EMLA-2020-1150-02-001

Subject: Submittal of the Supplemental Work Plan for Pilot-Scale Amendments Testing for Chromium in Groundwater beneath Mortandad Canyon, Revision 1

December 2019
EM2019-0455

Supplemental Work Plan for Pilot-Scale Amendments Testing for Chromium in Groundwater beneath Mortandad Canyon, Revision 1

Figure 3.2-1 Proper downhole configuration for a dilution tracer test

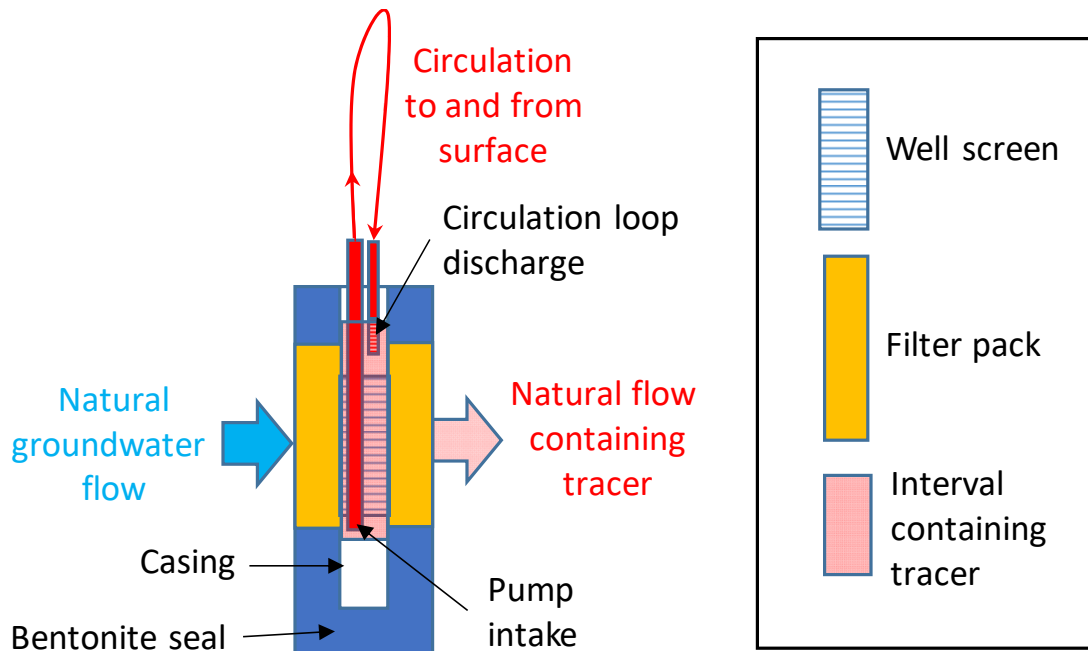
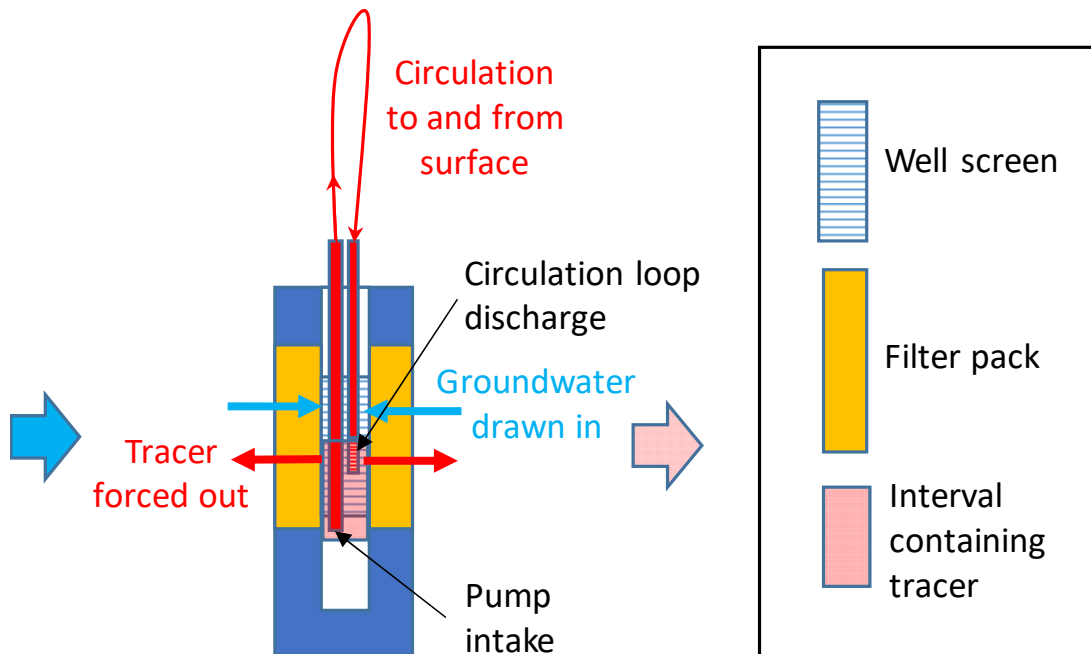
Enclosed please find two hard copies with electronic files of the "Supplemental Work Plan for Pilot-Scale Amendments Testing for Chromium in Groundwater beneath Mortandad Canyon, Revision 1." The work plan has been revised to switch Figures 3.2-1 and 3.2-2 per a comment received from the New Mexico Environment Department via email on November 6, 2019.
